CERTIFICATE OF APPROPRIATENESS

Property: 1641 Columbia Street, lot 3, block 114, Houston Heights Subdivision. The property includes a historic 1,328 square foot, one-story wood frame single-family residence situated on a 6,600 square foot (50' x 132') interior lot.

Proposal: Alteration – Relocate the one-story 1,330 square foot contributing residence forward to 20' front setback. Brick porch columns and knee walls will be disassembled with care and reinstalled to match original conditions at the new location. Any damaged brickwork to be verified by staff and replaced in kind. The existing asbestos siding will be removed to expose the original 117 siding. Post relocation, a two-story 2,800 square foot addition with attached garage will be constructed. Addition will measure 41'-6" wide and 60'-3" deep overall. The one-story portion of the addition will have an eave height of 10'-1" and a ridge of 22'-4"; the two-story portion will have an eave height of 20'-4" and a ridge height of 27'-4".

Recommendation: Approval

FRONT WALL BLOCKFACE COMPARISON
SANBORN FIRE INSURANCE MAP 1924-1950

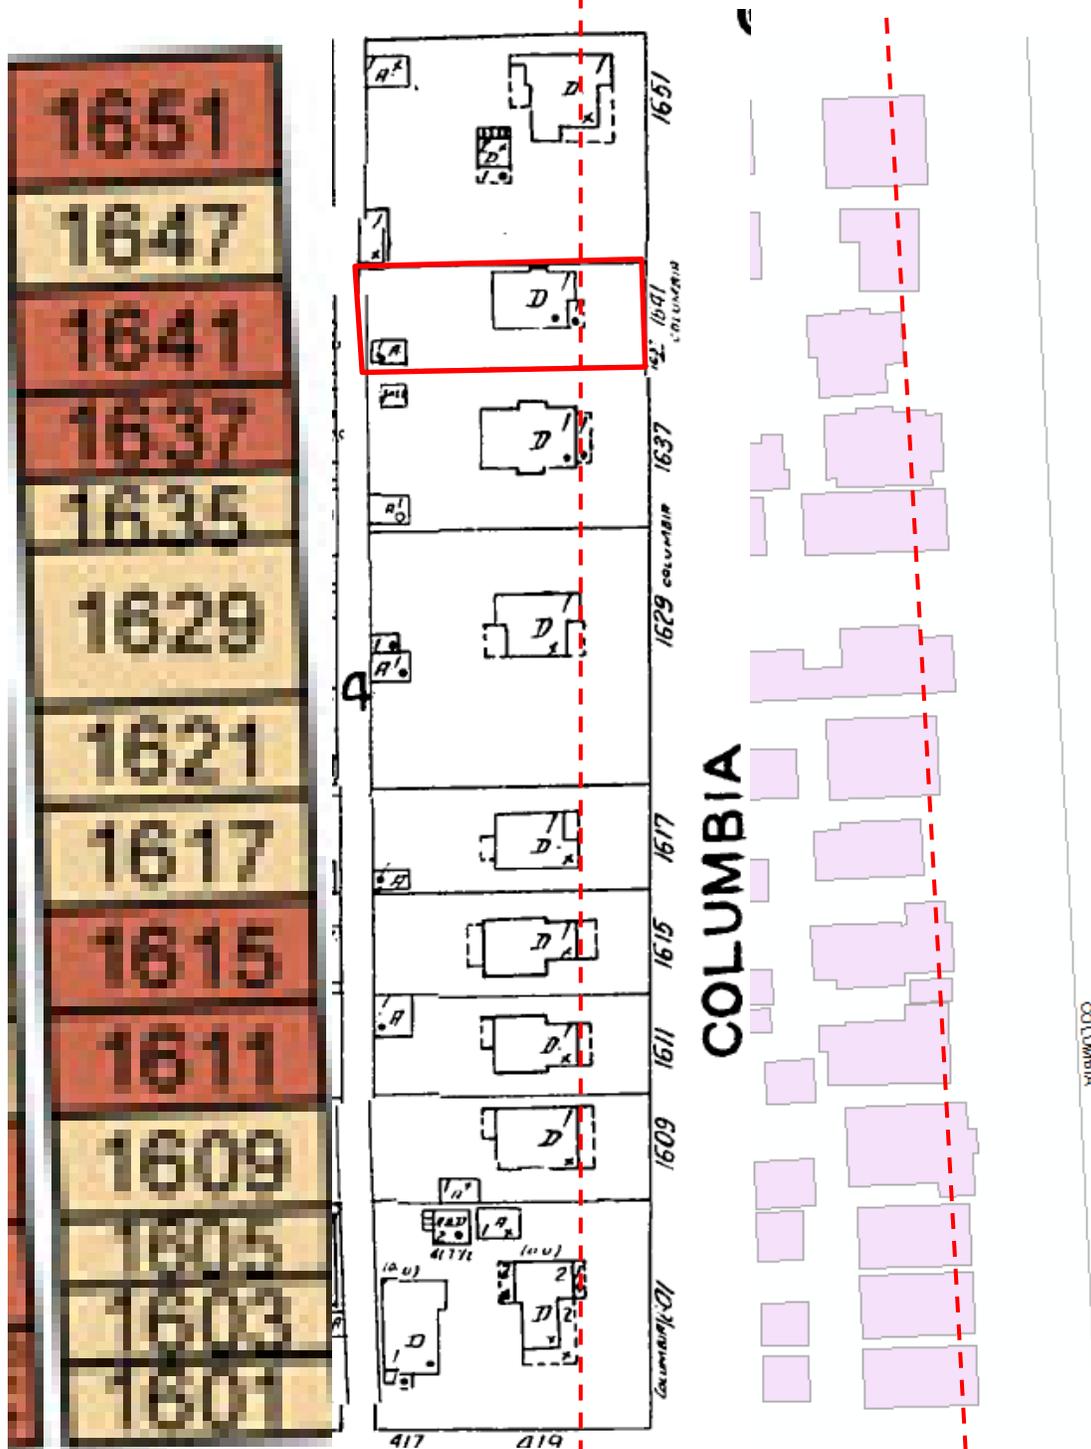
| <input checked="" type="checkbox"/> | <input type="checkbox"/> | <input type="checkbox"/> | (10) The setback of any proposed construction or alteration must be compatible with existing setbacks along the blockface and facing blockface(s);

<i>Though the 1600 block of Columbia Street originally featured a consistent front setback, loss of historic structures and the construction of new buildings at a reduced setback have removed that consistent setback line.</i> |
